Docket Number:	09-AFC-05C
Project Title:	Abengoa Mojave Compliance
TN #:	259279
Document Title:	Mojave Solar Project Response to Data Request Set 3
Description:	N/A
Filer:	Deric Wittenborn
Organization:	Ellison Schneider Harris & Donlan LLP
Submitter Role:	Applicant Representative
Submission Date:	9/25/2024 9:41:45 AM
Docketed Date:	9/25/2024

**MSP Two New Permanent Evaporation Ponds-Data
Requests-Set 3- Responses**

FIGURE 4

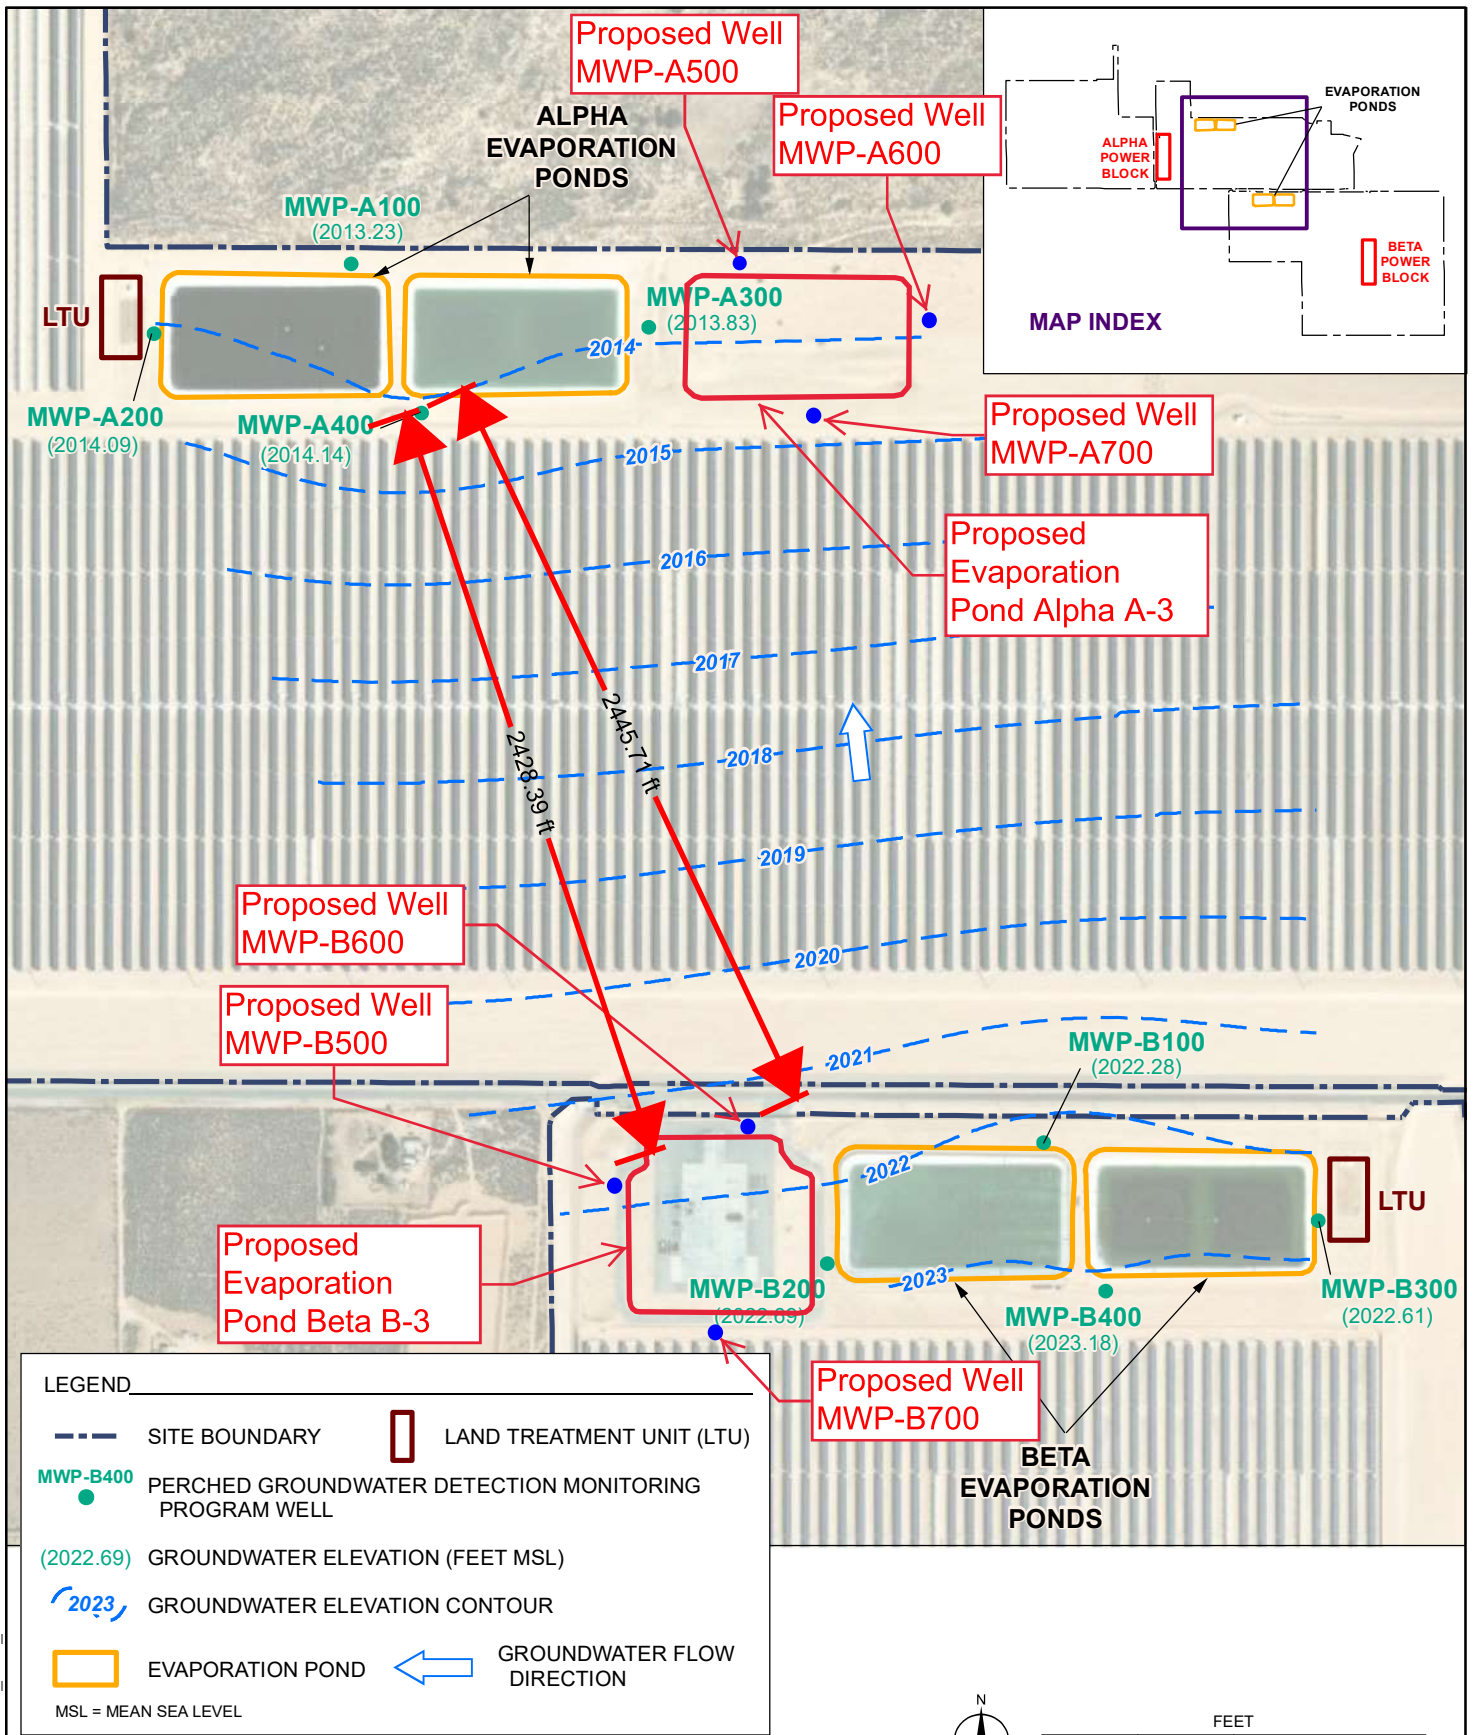
Follow-up to Data Request, Set 2, Response No. 6: Based on Figure 4, it appears that the scope of work does not include construction of wells in the downgradient direction for both the Alpha and Beta ponds. Downgradient wells are necessary to establish background quality in the event of a release.

3. The scope of work must be revised to include one well on the south side of both new evaporation ponds. Please provide an updated figure and scope of work that shows the proposed project revision includes one well on the south side of both new evaporation ponds.

- 5- An additional perched groundwater detection monitoring program well will be installed on the south side of each of the proposed, new Alpha and Beta evaporation ponds.

MSP is also updating Figure 4 from the prior data response to include MWP-A700 and MWP-B700 on the south side of the proposed Alpha and Beta evaporation ponds, respectively. The updated figure is included in Appendix 1. These two wells will be installed in a similar manner as the existing and proposed perched groundwater monitoring wells, with an approximate 35 to 45 foot depth. The two

additional wells will provide background water quality and assist in the overall monitoring program for detecting leaks from the evaporation ponds.
